EPC Agenda Items # 3 & 4: Building Height & MPOS buffer Variances and Zone map amendment at Cottonwood Crossing eastside of Coors Blvd & 7 Bar loop intersection.

Project # PR-2023- 009105, PR-2023-009105

EPC Hearing Date: December 21, 2023

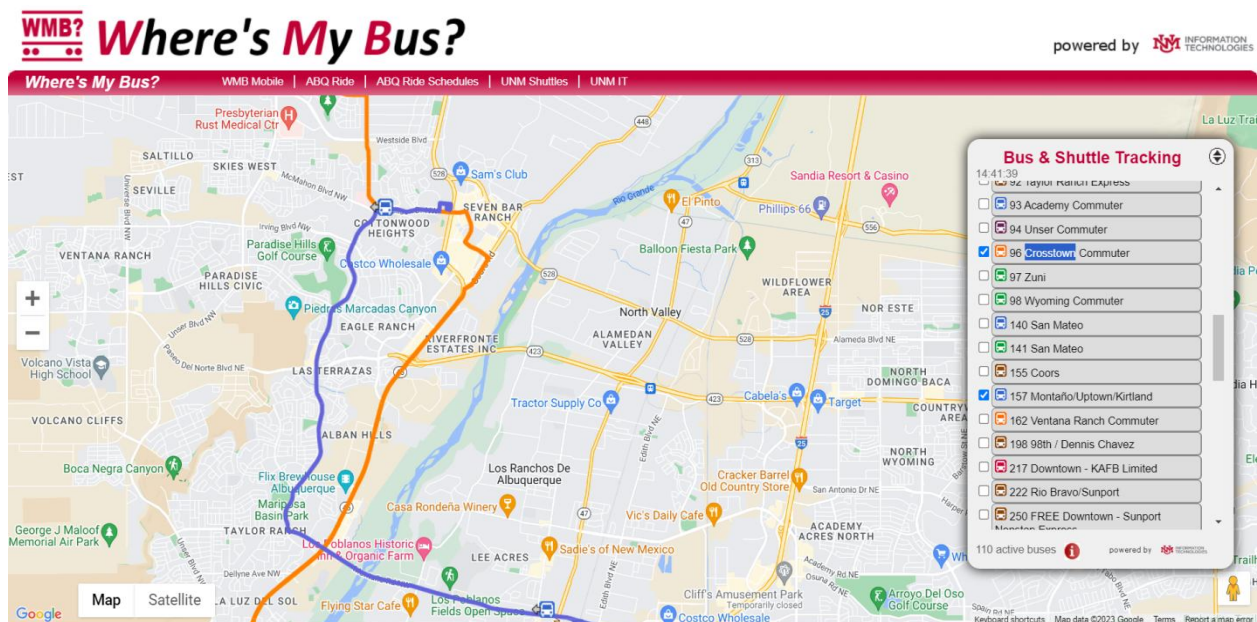
10) I am concerned about the architecture of the buildings not being in character with surrounding area by using metallic materials and a white color scheme. The color scheme should be southwest earth tone colors. See pg. 282 of the staff report of the building elevation.

There should be no variance to building height for any of the buildings including the cannabis and restaurant. None of the buildings should use metallic materials. They should use stucco with earth tone colors. to blend with the built and natural environment.

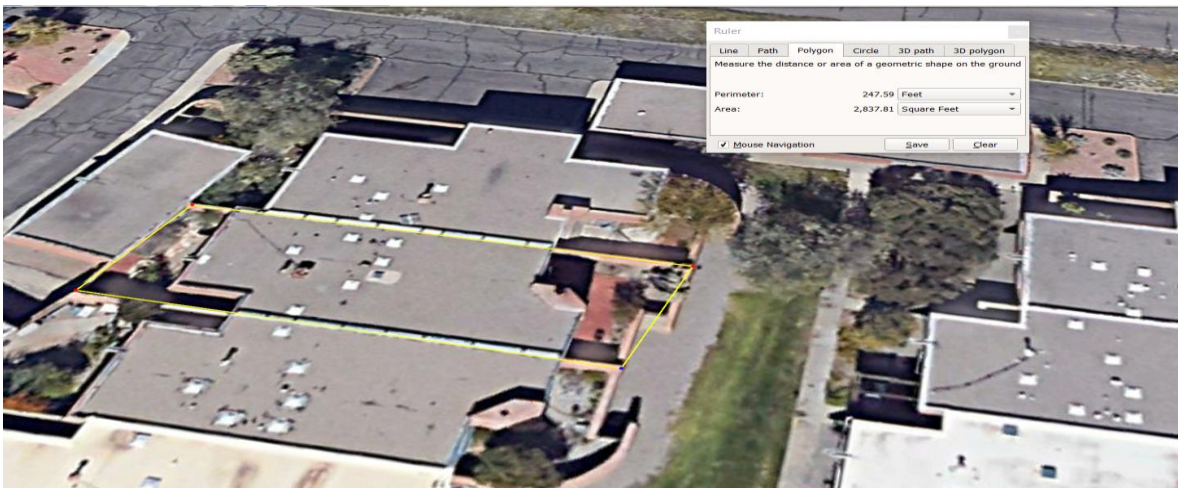
- 3) Most of the 14 Townhouses are on extremely small lots of 1,600 sf., except for one townhome being on a 2,256 sf lot, which is a more appropriate size. The 1,600 sf size is not consistent with Town homes already built on the west side along Coors Blvd. or near the river which are on 2,800 sf. lots. These town homes also have lots of common space. See photos below.

Existing west side town homes below have over 2,000 sf lots. 1,600 lots are too small for town homes.
La Luz Townhome lot is **2,837 sf** (near Coors and Dellyne).

Town Homes on Vista Grande NW, north of I-40, overlooking the Rio Grande. Photo shows lot size **2,800 sf**. Lot includes garage, driveway, and patio. These town homes include common open space as well.

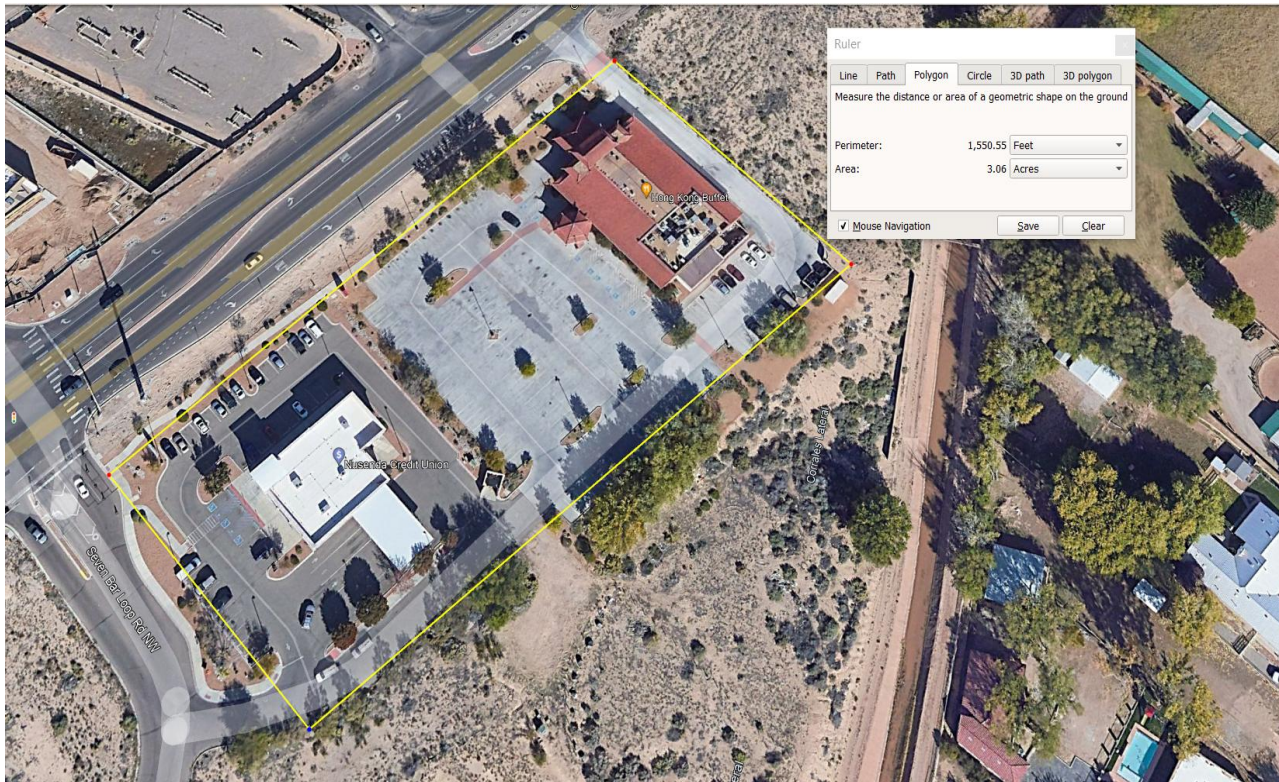
Below is the Hong Kong restaurant and Credit Union along Coors Blvd. at entrance to subject site. Together the 2 lots are 3 acres. There are only 2 uses on the 3 acre site. The subject site we are reviewing is southeast of the Hong Kong Restaurant and Credit Union. It also is 3 acres. This application is proposing 4 uses on a 3 acre site, and as a result wants several variances to be able to squeeze everything onto the 3 acre parcel. We request that the applicant reduce the amount of density or number of uses to better fit the site without seeking or needing any variances.
